Accessibility Construction Progress Observation Report #3 Final

Mauldin Center Apartments

Terracon Project No. F8206013

SC Housing Project Number 2019-016

#24 - Path to Building Entrance

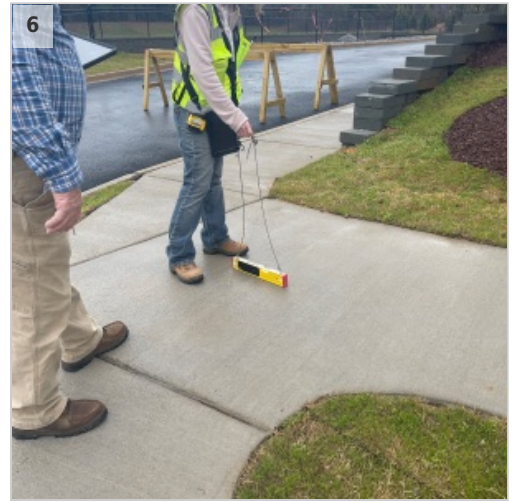
Katie Rich	Photo 1	16 Mar 12:18 PM
Katie Rich	Photo 2	16 Mar 12:18 PM
Katie Rich	Photo 3	16 Mar 12:19 PM
Katie Rich	Photo 4	16 Mar 12:19 PM
Katie Rich	Photo 5	16 Mar 12:19 PM
Katie Rich	Photo 6	16 Mar 12:20 PM
Katie Rich	Issue: The path leading to street level has a slope greater than 5% past the turn. Handrails with handrail extensions would be required at this area that extend to a level landing. However, per the contractor, the sidewalk closest to road is city property and will be removed soon due to highway expansion. The road expansion may make this change in elevation worse.	16 Mar 12:21 PM
Katie Rich	Photo 7	16 Mar 12:22 PM
Katie Rich	The slope of the path from the Olii Place sign to the front door is compliant.	16 Mar 12:22 PM
Katie Rich	Photo 8	16 Mar 12:25 PM

● #26 - Path to Dumpster

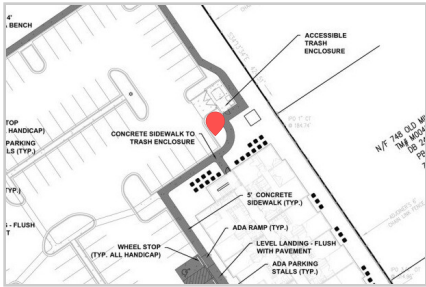
Melissa Middleton	Photo 1	21 Mar 06:37 AM
Melissa Middleton	Photo 2	21 Mar 06:37 AM
Melissa Middleton	Photo 3	21 Mar 06:37 AM
Melissa Middleton	Issue: The paving at the door to the dumpster does not have at least 18" of maneuvering clearance past the latch side of the door on the pull side. Extend paving.	21 Mar 06:38 AM

● #29 - Unit Type 1A-HC & 2A-HC Unit# 114 (104) & 116 (106) (S+H)

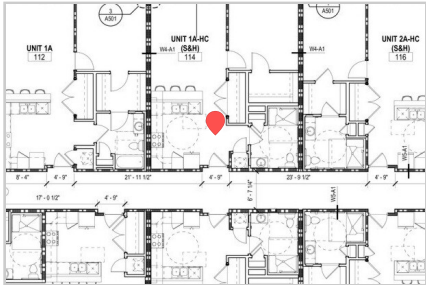
Katie Rich	Photo 1	21 Mar 07:40 AM
Katie Rich	Issue: A lighted doorbell button connected to an audible and strobe alarm installed is required for each sight- and hearing- impaired unit.	21 Mar 07:41 AM
